3.4.4.1.4b Load Case 4: Non-Mechanistic Tipover of MPC-89 CBS Basket Design

3.4.4.1.4c Load Case 4: Non-Mechanistic Tipover of MPC-44 Basket Design

Figure 3.4.15E: Maximum Plastic Strain – MPC-44 CBS Fuel Basket

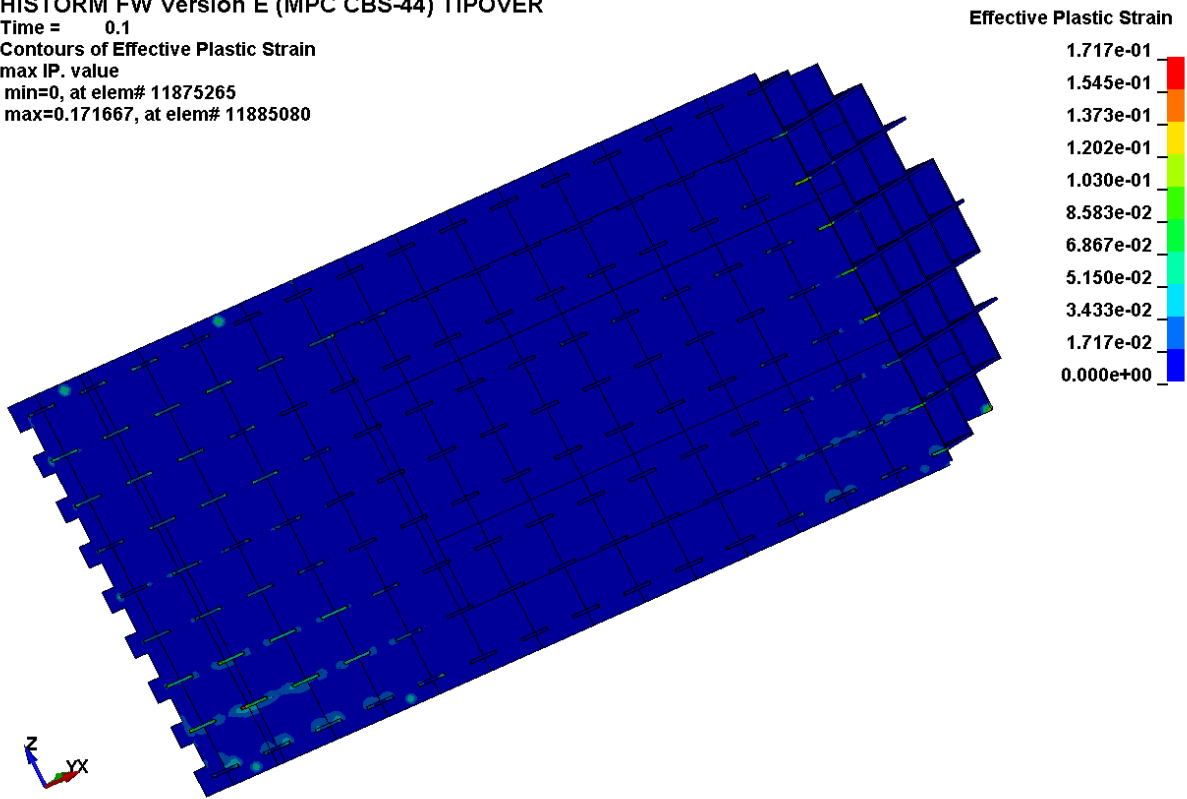
Like other basket designs, the response of the MPC-44 CBS basket during the tipover event is predominantly elastic with very localized areas of plasticity, as shown in Figure 3.4.15E. Nonetheless, to insure compliance with the allowable limit in Subsection 2.2.8, the maximum lateral deformation of the most heavily loaded CBS basket panel, at any elevation within the active fuel region, is obtained from the LS-DYNA solution and reported in Table 3.4.19.
